Re: Notice of Intent Application Review Letter #1
1 Paddock Lane, Franklin, Massachusetts (Map 211, Lot 118)
(DEP File # 159-1307)

Goddard Consulting, LLC, (Goddard) is pleased to submit this response letter on behalf of Nabih Younis (the Applicant), to provide responses to the initial project review comments issued by BETA Group, Inc. regarding the Notice of Intent (NOI) application filed for 1 Paddock Lane (DEP File # 159-1307).

Planting Plan

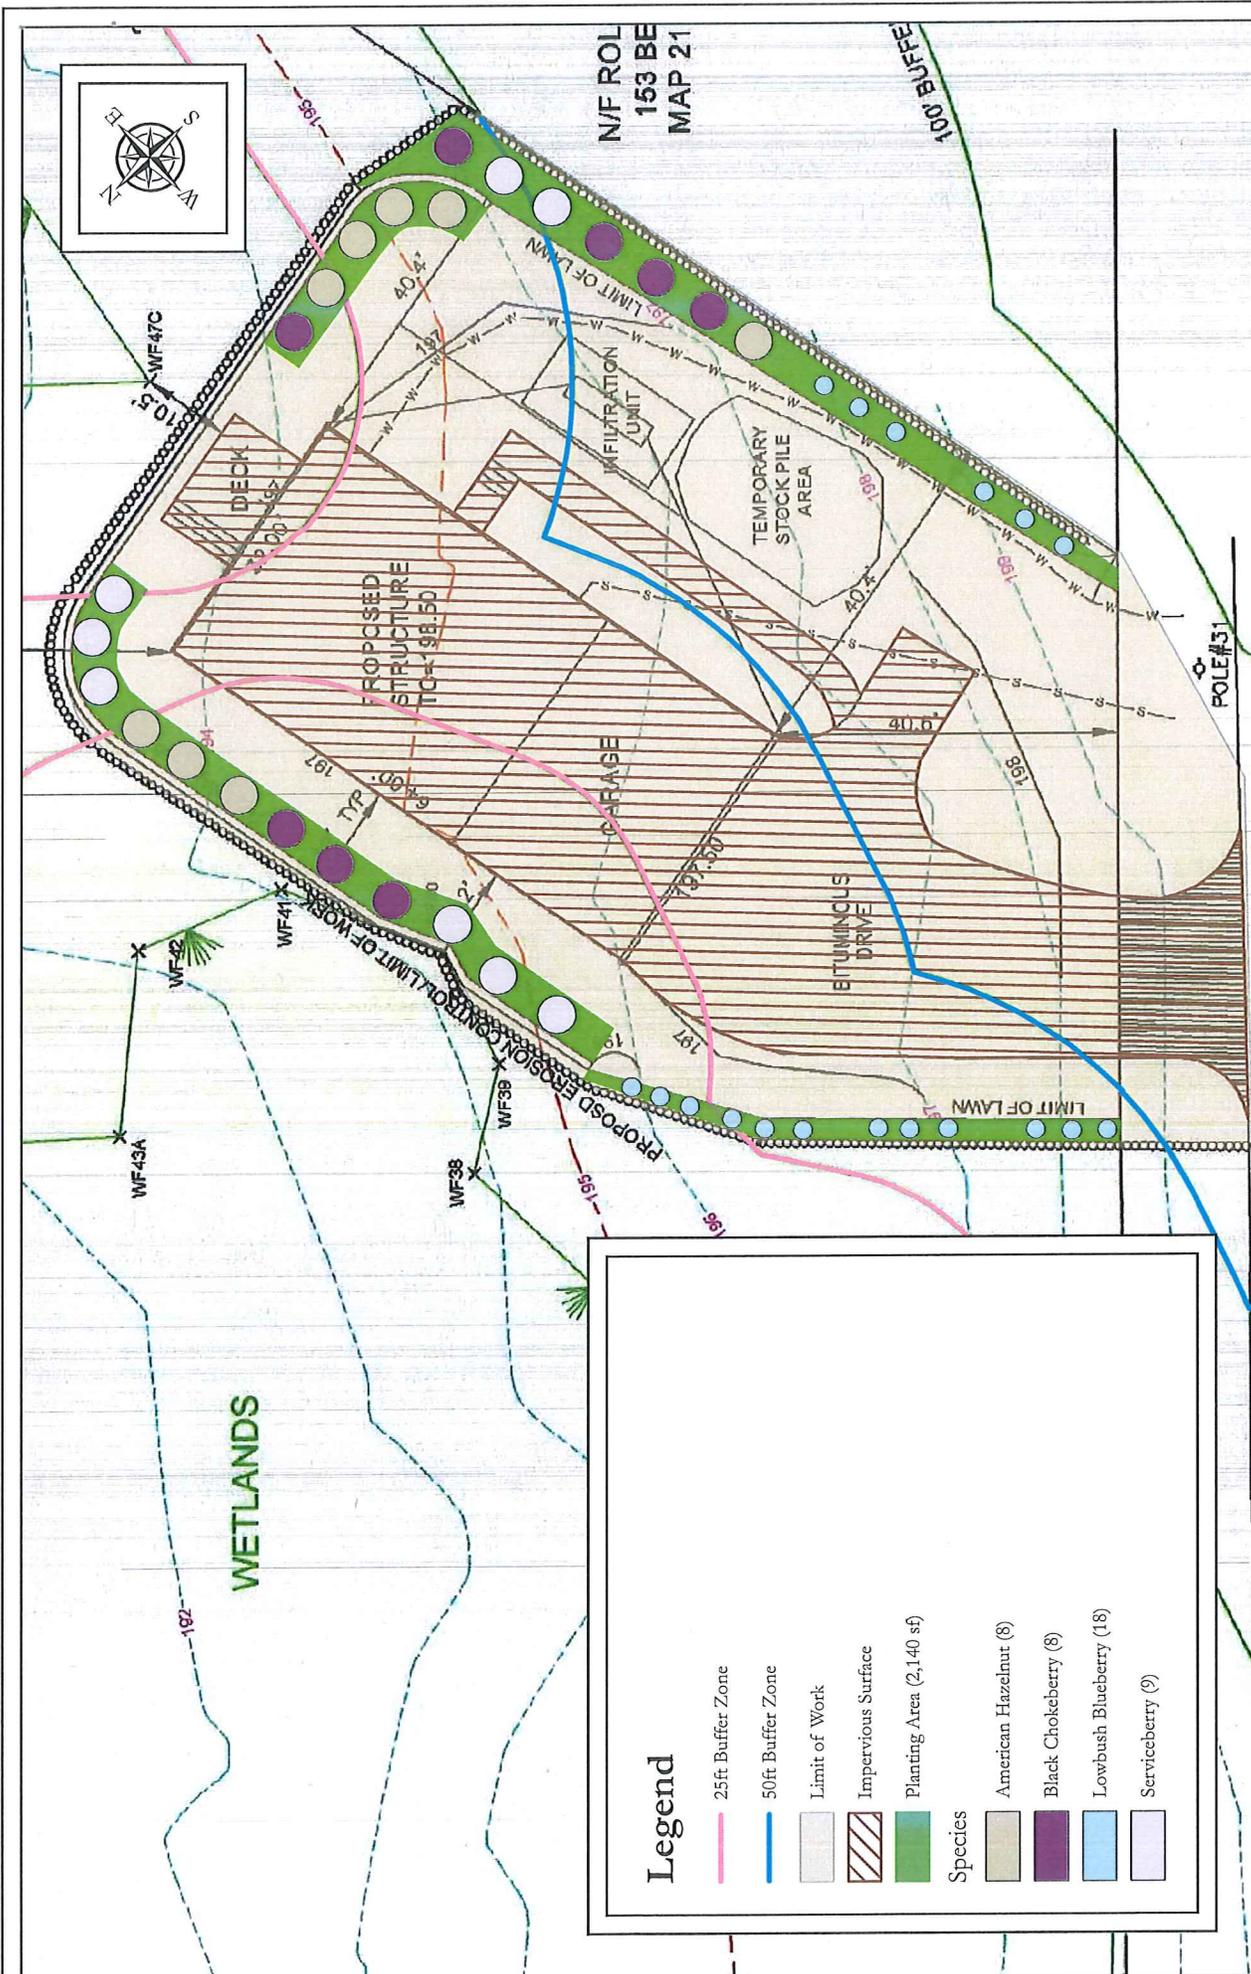
W16	Provide a Natural Heritage and Priority Habitats and Estimated Habitats Map and FEMA Floodplain Map, as required for NOI submissions to the Franklin Conservation Commission (Bylaw Section 7.17.1).	An updated Orthophoto, demonstrating that no Natural Heritage habitat areas are located on site, and FEMA Floodplain Map, demonstrating that no FEMA Flood Zone is located on site, are attached.
W17	The Applicant has provided a Variance request for work within BVW and the 0-25', 25-50', and 50-100' Buffer Zones in accordance with Bylaw Regulation Section 5. The submitted alternatives analysis is not sufficient to demonstrate that a practicable project with fewer impacts is not achievable. The alternatives analysis notes that a scaled back development would "...provide significantly scaled back mitigation..."; however, the proposed mitigation is only required due to the proposed wetland fill. No mitigation has been provided for forested Buffer	An Updated Alternatives Analysis is attached to further clarify and compare potential project designs. This also includes discussion of avoidance, minimization and mitigation of impacts, including the newly proposed planting area.

This project proposes the construction of another single-family home that includes a garage, driveway and appurtenances on the southern corner of the lot within the jurisdictional buffer zones discussed above. As mitigation to offset construction within the buffer zone, the project proposes to convert a portion of the proposed development area into a naturalized area planted with native vegetation along the edges of the retaining wall and limits of lawn. It will total approximately 2,140 square feet of planting. The plantings will enhance the function of the wetland by providing habitat and forage value for wildlife as well as increasing attenuation and filtration of runoff and pollutants.

Plantings will be installed according to the attached plan. Precise siting of plants may be determined by the wetland scientist or landscape professional in the field prior to installation. All plantings (reference the planting list in section D) shall be distributed throughout the area as shown. All plantings will be removed from burlap sacks, wire cages and plastic containers prior to planting. Each plant will have its roots loosened
